CALL UTILITY NOTIFICATION
CENTER OF COLORADO
1-800-922-1987
CALL 2-BUSINESS DAYS IN ADVANCE
BEFORE YOU DIG, GRADE, OR EXCAVATE
FOR THE MARKING OF UNDERGROUND
MEMBER UTILITIES.

ABERT RANCH SUBDIVISION

SD1

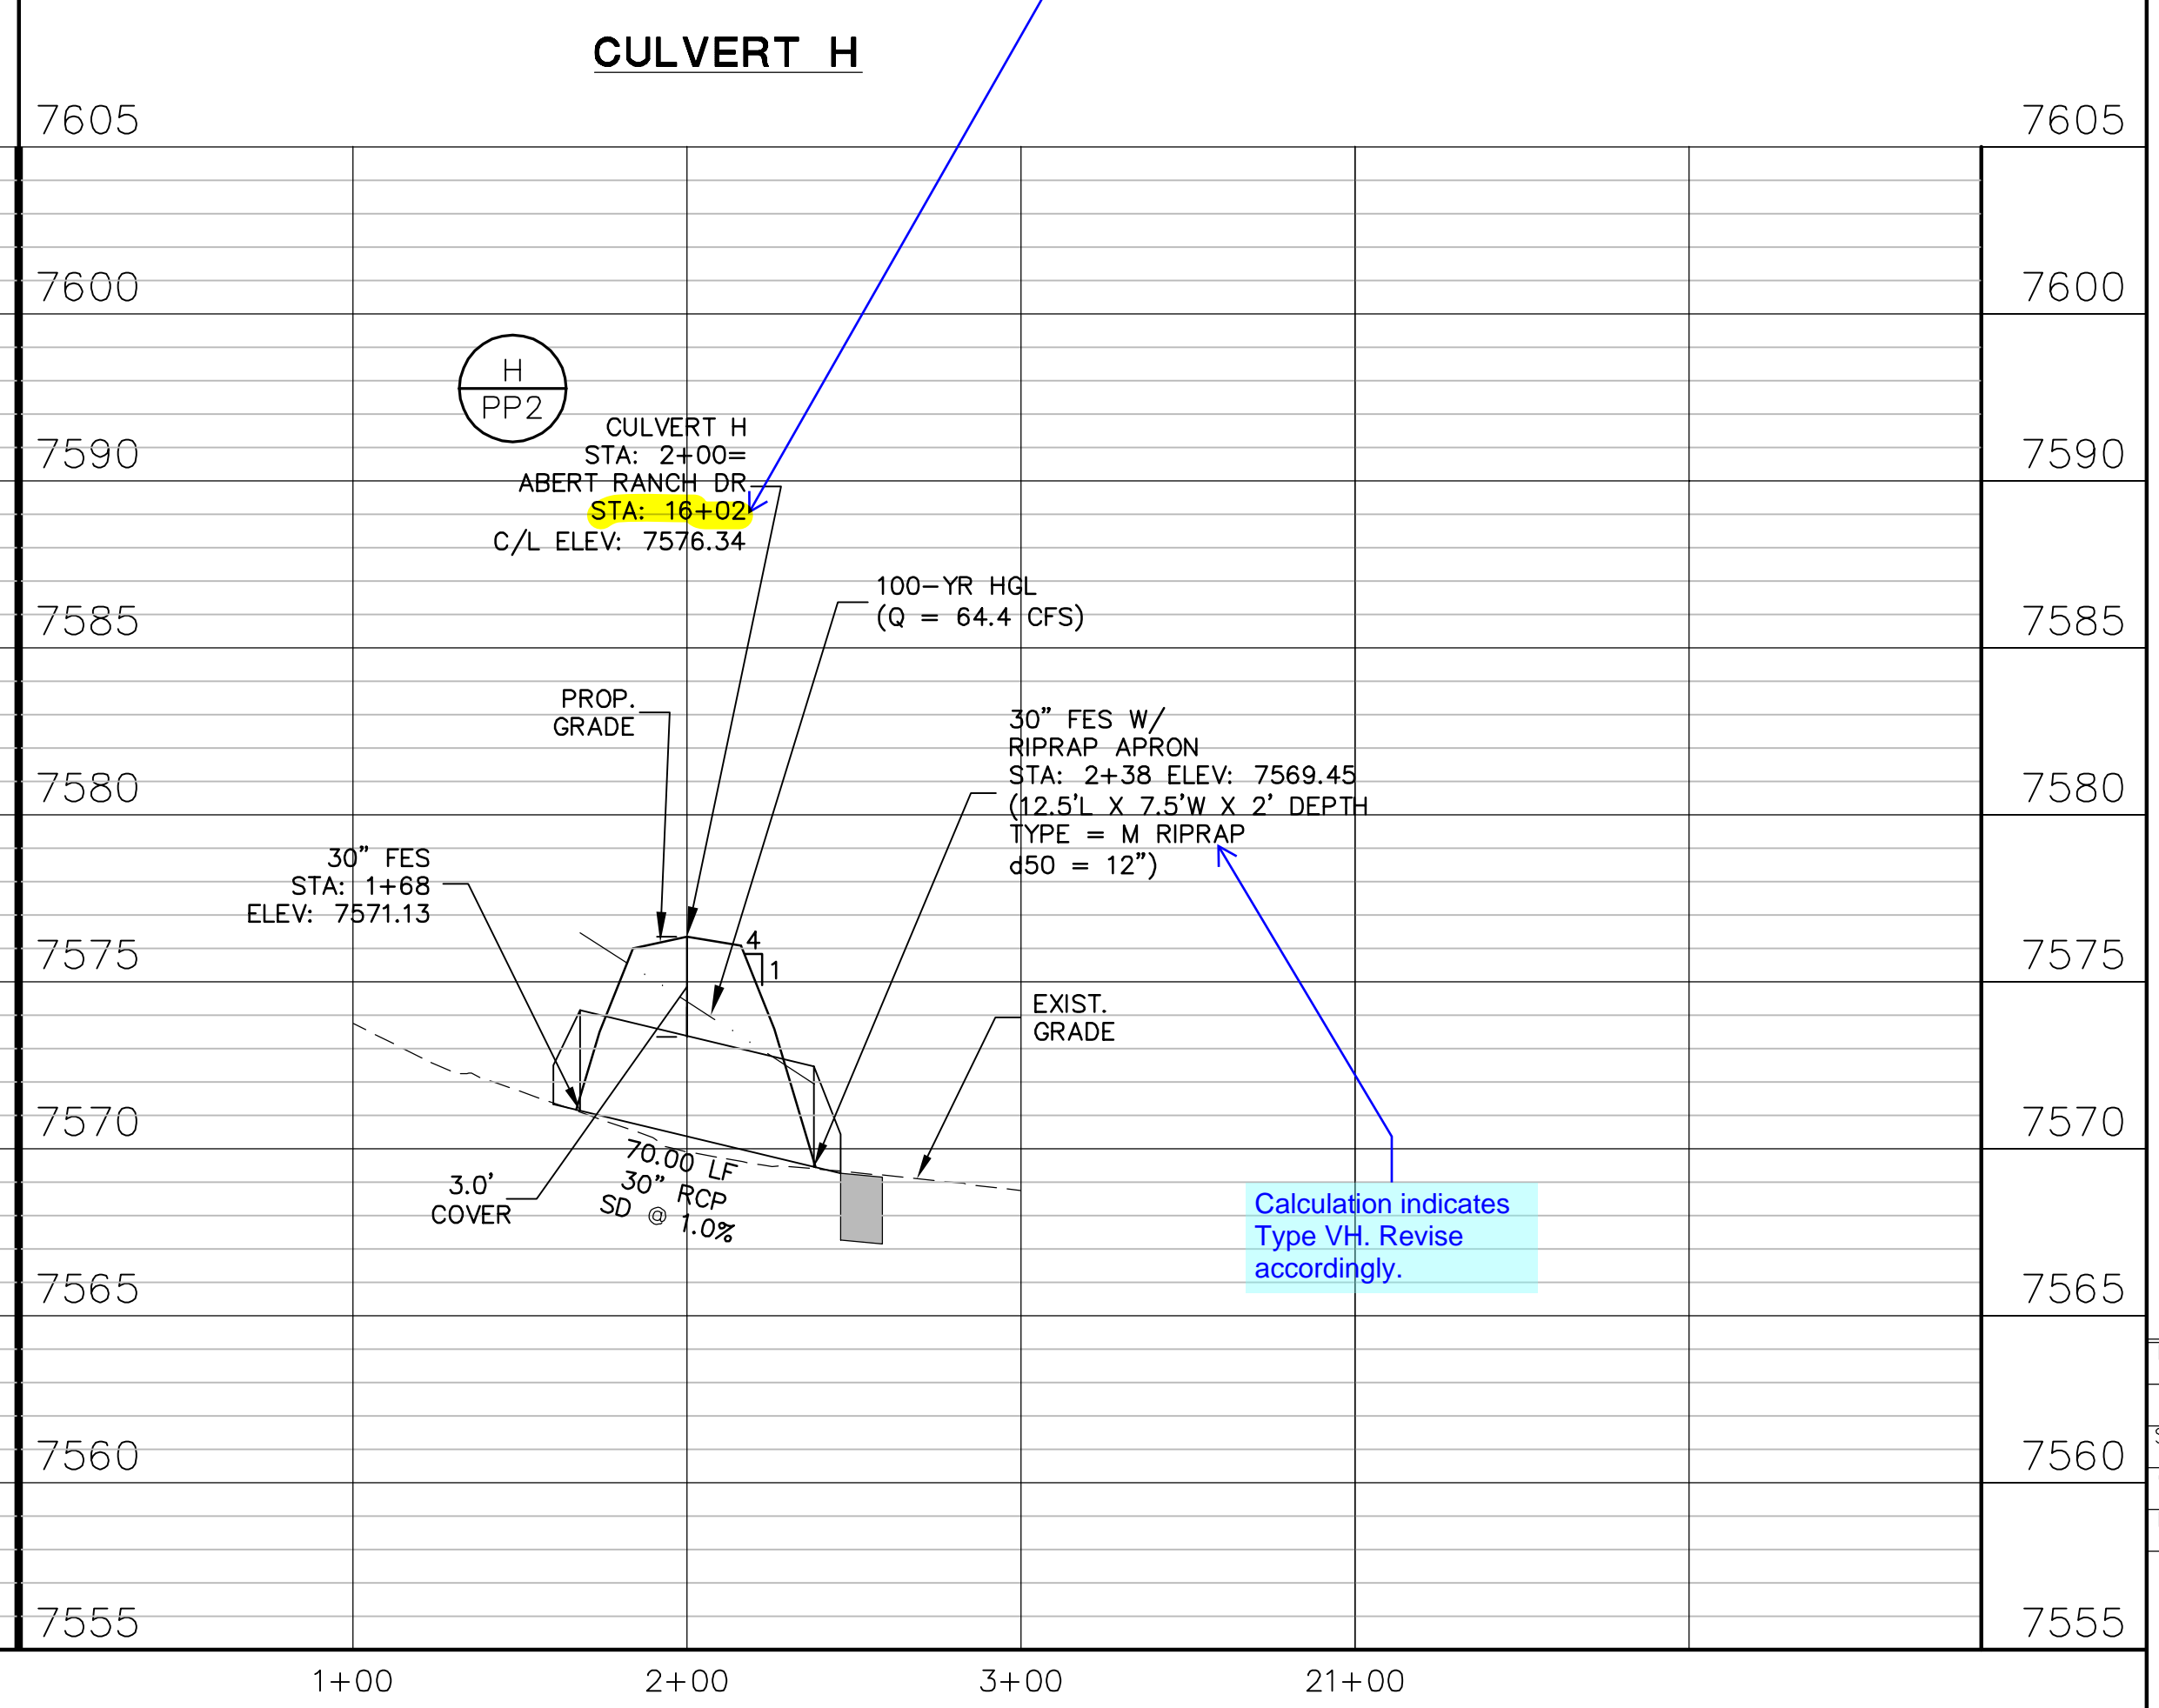
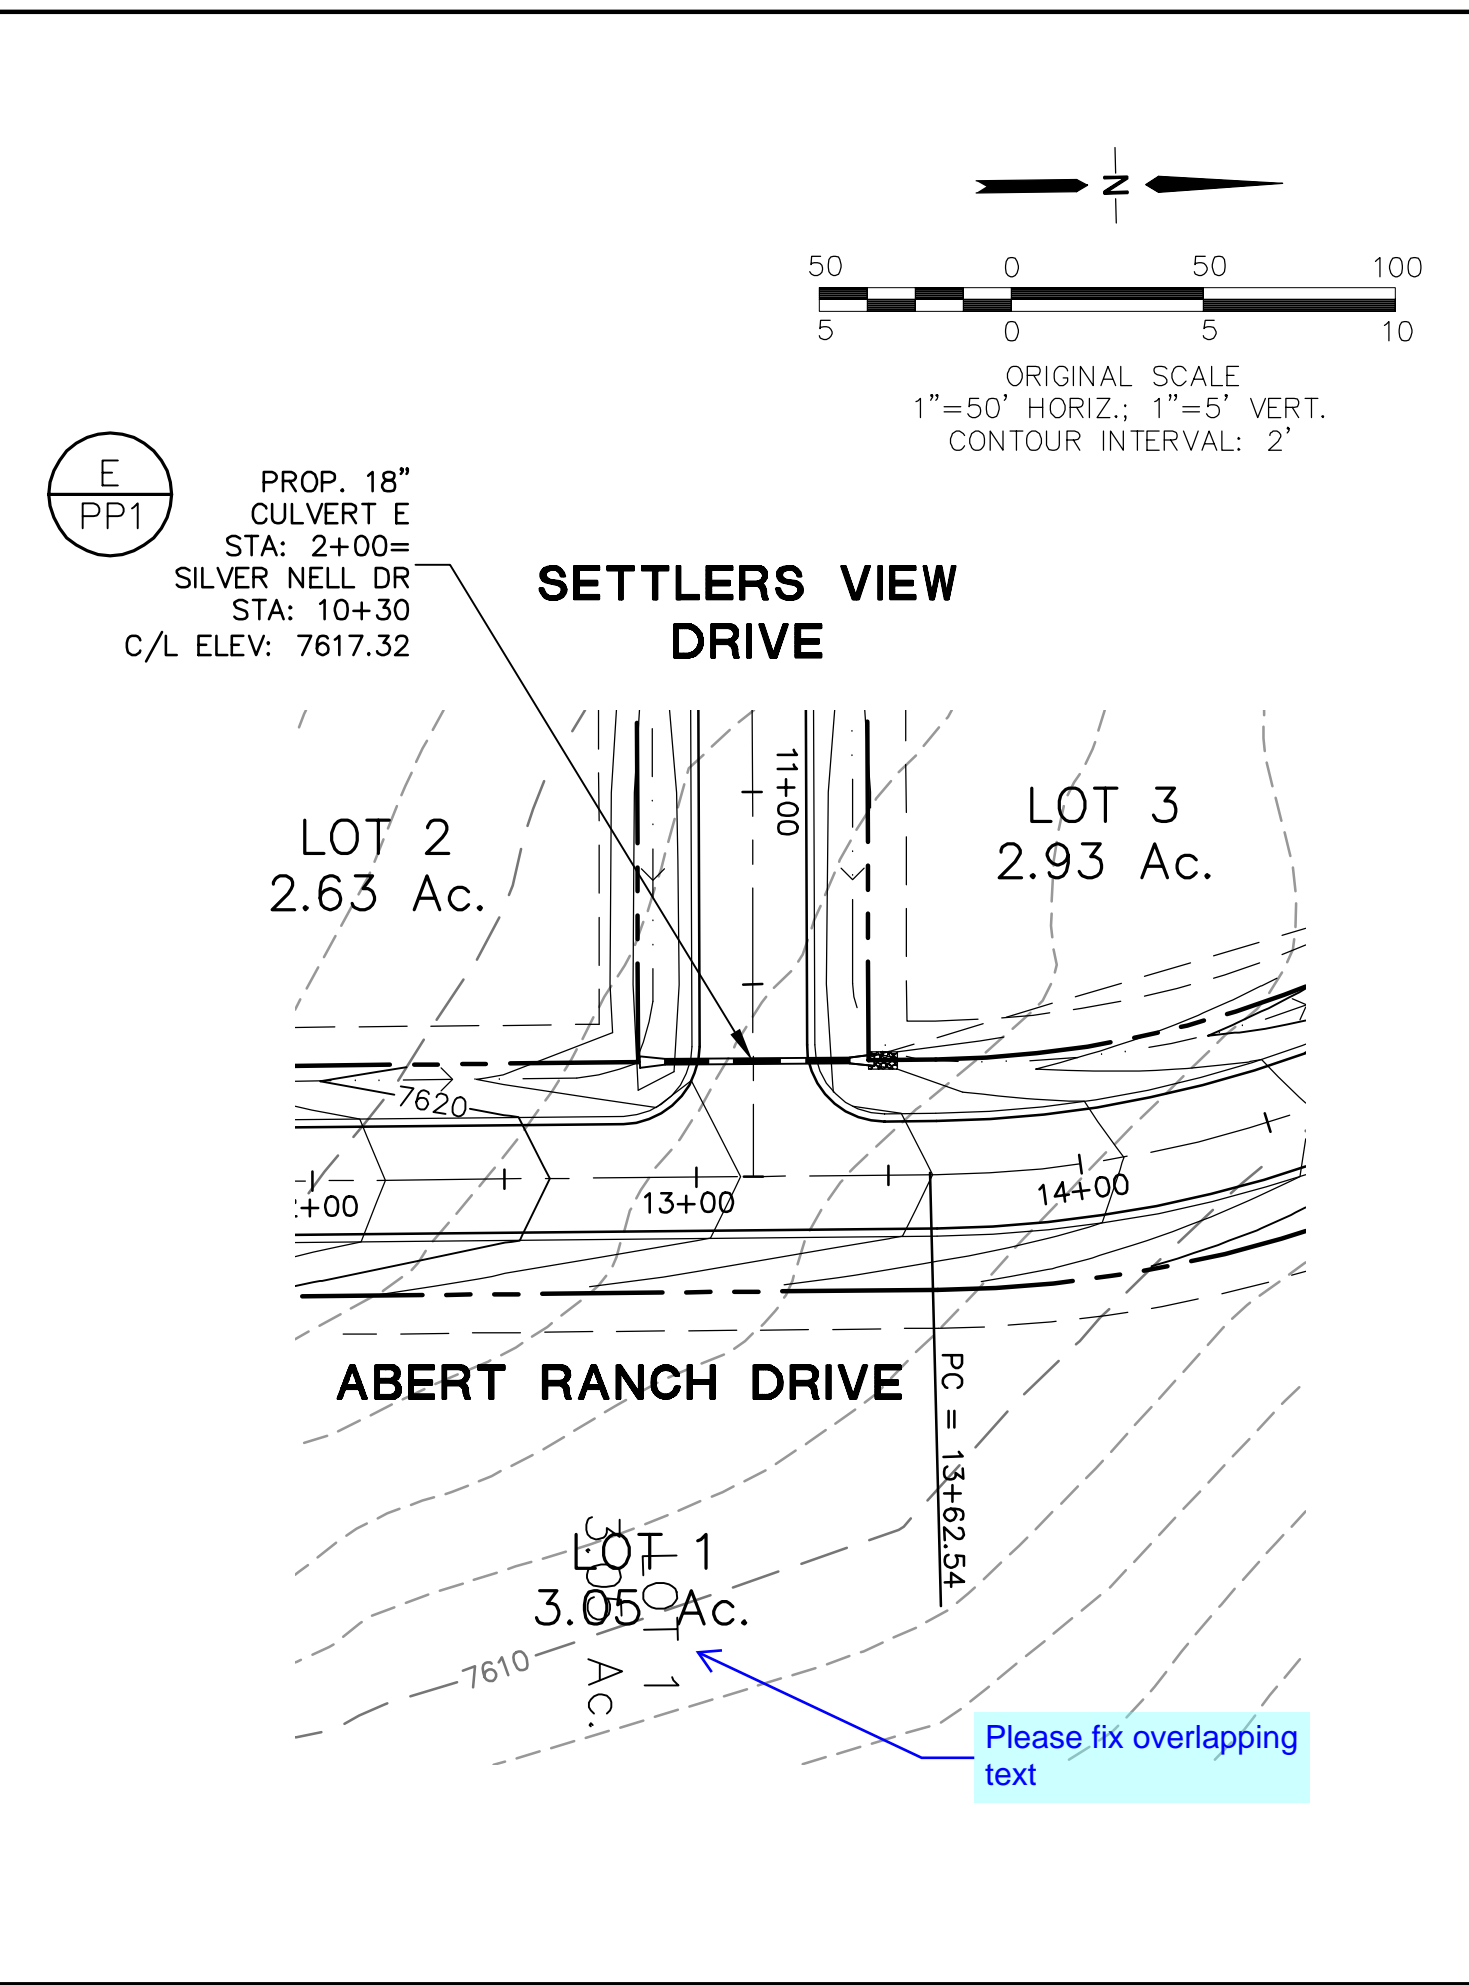
Markup Summary
